Re: Conceptual Scheme - "The Heights"  
File # - 04618003 & 04619016  
Application # - PL20240162

*As the community most affected by the development of The Heights, the Escarpment Park Homeowners Association (EPHA) would like to present the following documents highlighting our main concerns addressing:*

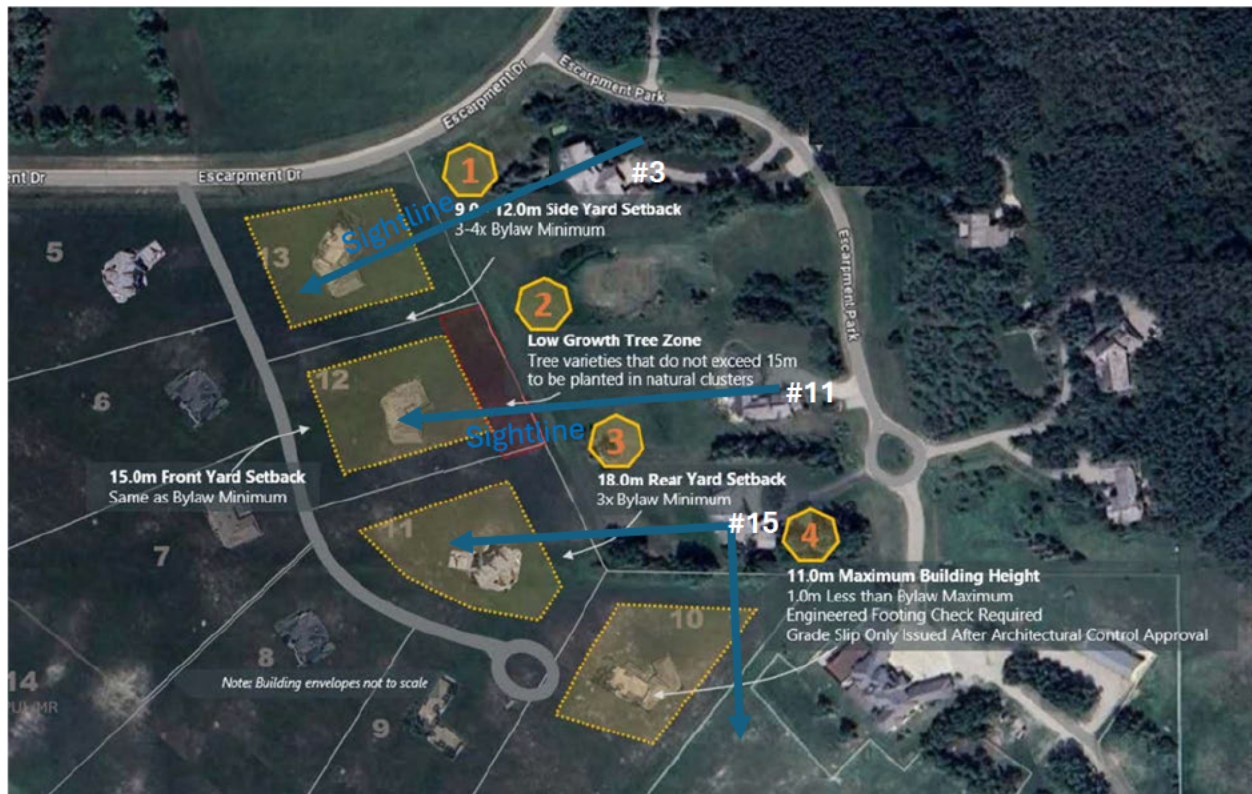
Explicitly defining a house placement envelope and maximum home size within each property parcel is a means to control sightline obstructions ([Figure 1](#); modified Map 9 from CS) for the existing EPHA homeowners and future The Heights homeowners alike. For the sake of argument herein, only concerns for the EPHA are brought forward below.

- Sightlines for Escarpment Park existing homes are not honoured spatially with current plan. In drawing below ([Figure 1](#); Map 9 from CS) House #1 (aka Escarpment Park #3) is affected by Lot 13, House #3 (aka Escarpment Park #11) is affected by Lot 12, while House #4 (aka Escarpment Park #15) is affected by Lot 10 and 11. Blue

arrows are drawn to show the focus direction for each home (Escarment Pk #3, #11, and #15 Figure 1).

Tab A. Diagram #1 showing suggested municipal reserve if subdivision of Block 13 and Lot 4 take place at the same time

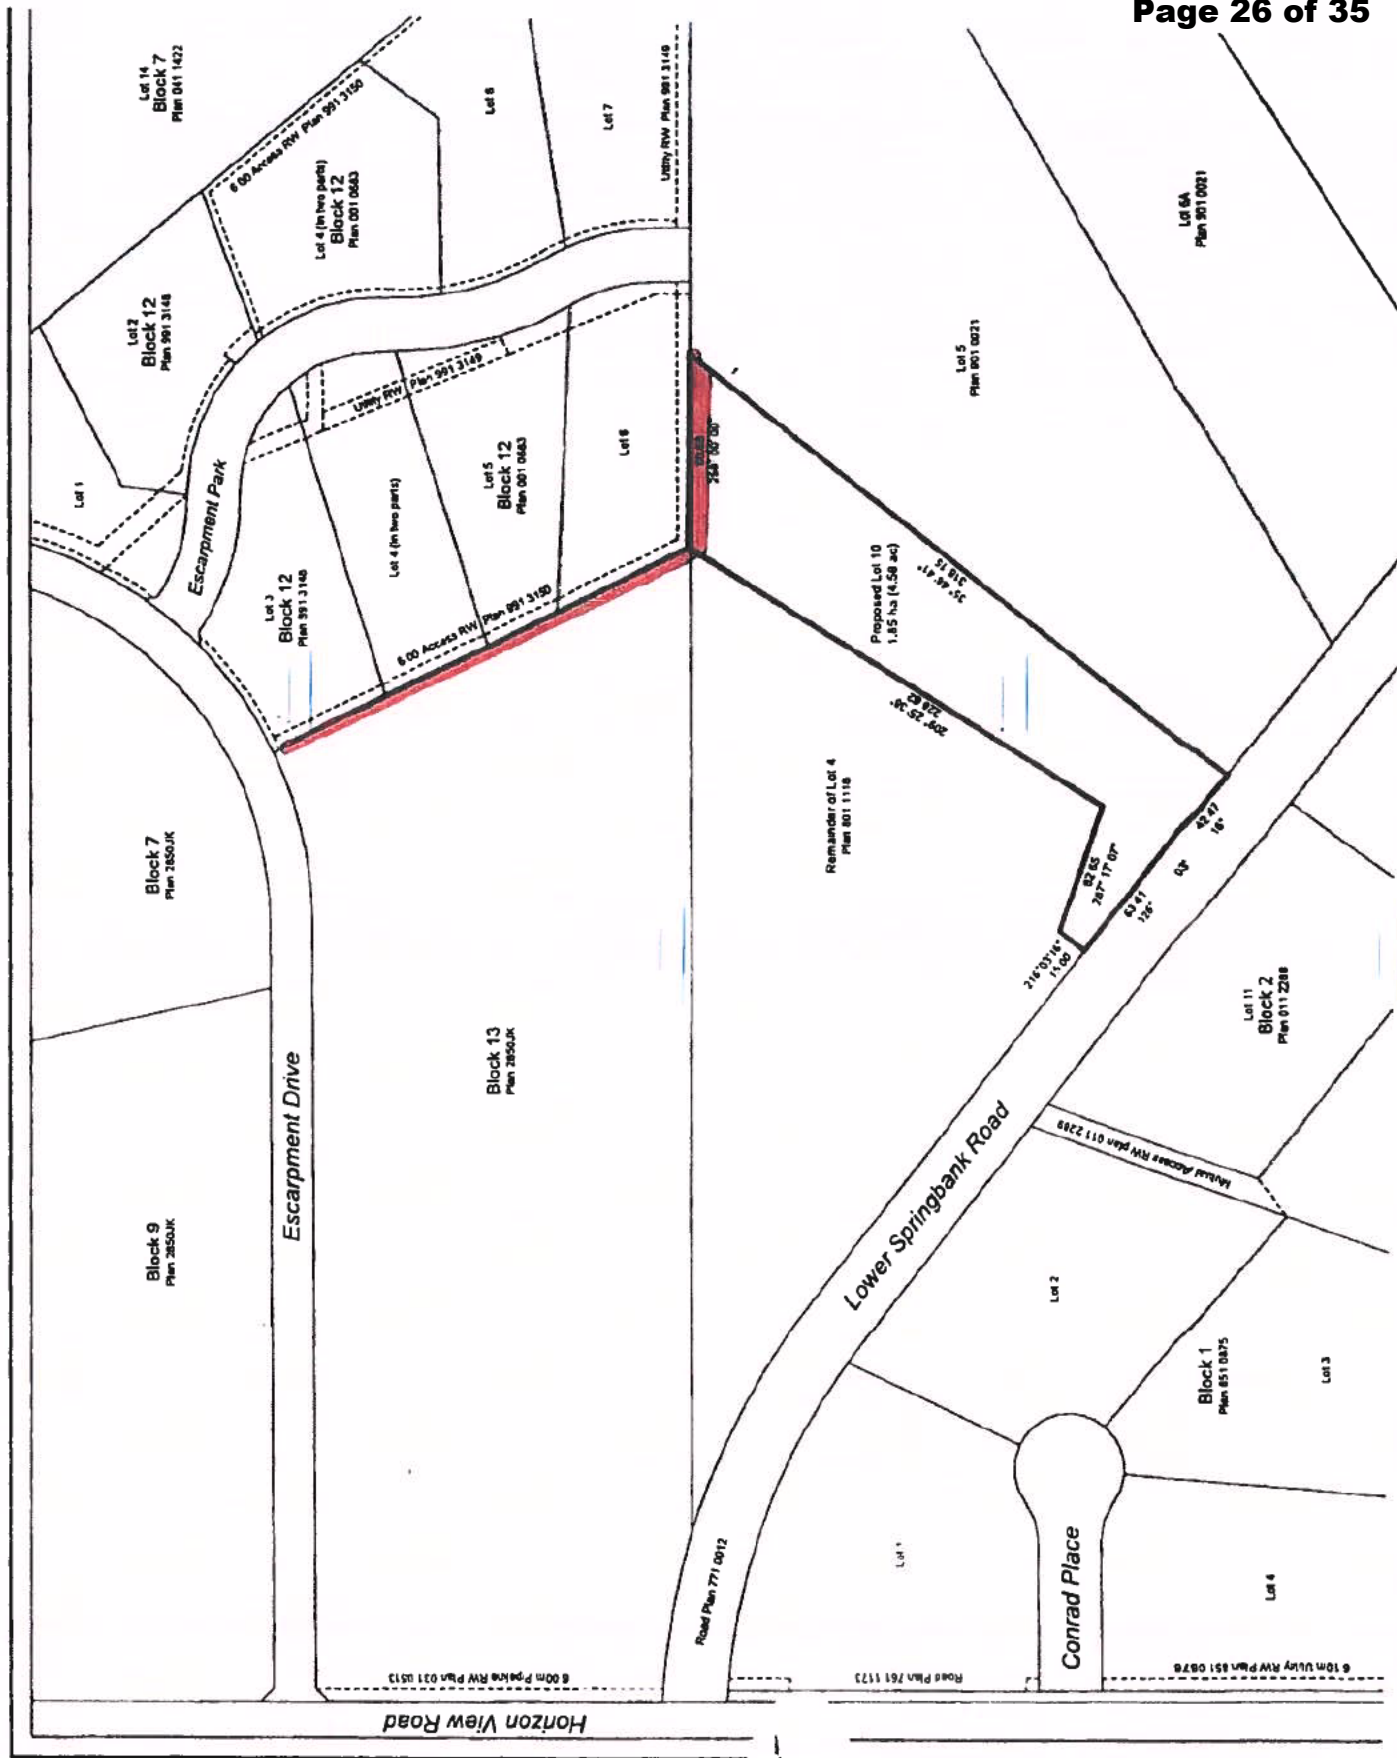
- (iii) put a 25 meter fire break as “an environment reserve” or “municipal reserve” at the west end of the development – which shall have a road access to fire fighting equipment and crews who can access the water system in the Escarpment Park development and the development itself. See Tab A (if whole subdivision is approved) or Tab B if the Developer seeks to approve Application #1

The 25 meter reserve needs to have the grass cut and roadway access maintained so:

- (a) emergency access vehicles – like fire trucks can get access the area from Escarpment Drive to fight fires; and
- (b) a natural fire break is constructed to give time to react. The emergency fire vehicles will need to connect to the Westridge fire hydrants next to my house in order to access water to fight the fire.
